SER23-025
08/23/2023

Subject: Field Action R-1009 Aspen APU Evaporator Drain Pan Inspection

Figure 1. Corner Welds Missing

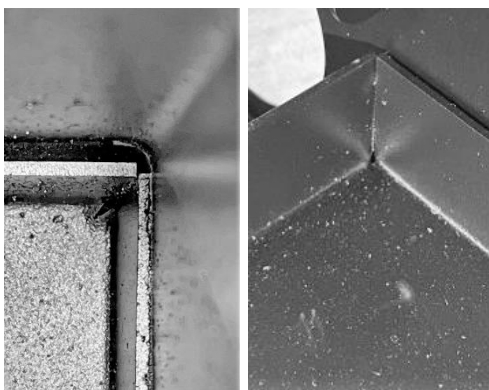
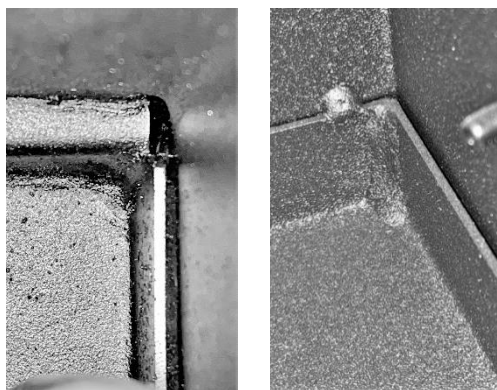
Remove the CCU evaporator cover. Refer to 62-12174 for removal instructions. Inspect the corners of the drain pan for missing or incomplete welds (Figure 1). The inspection can be performed without removing the evaporator. If the welds are present and complete, no further action is required.

Rework

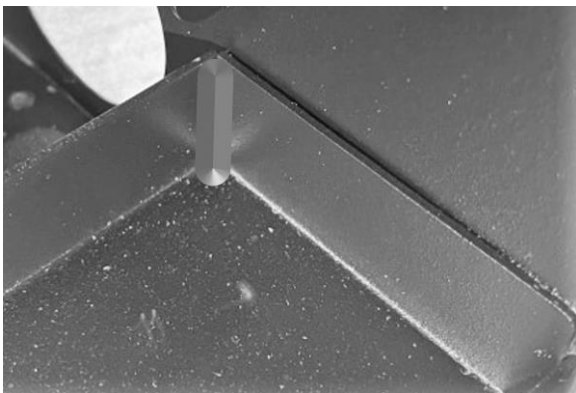
Remove the evaporator core. Refer to 62-12174

Remove any water from the drain pan.

Apply 5/16" (8mm) bead of SikaFlex® 221 or equivalent to each of the corners of the drain pan as shown.

Allow sealant 60 minutes to cure before running unit in cool mode.
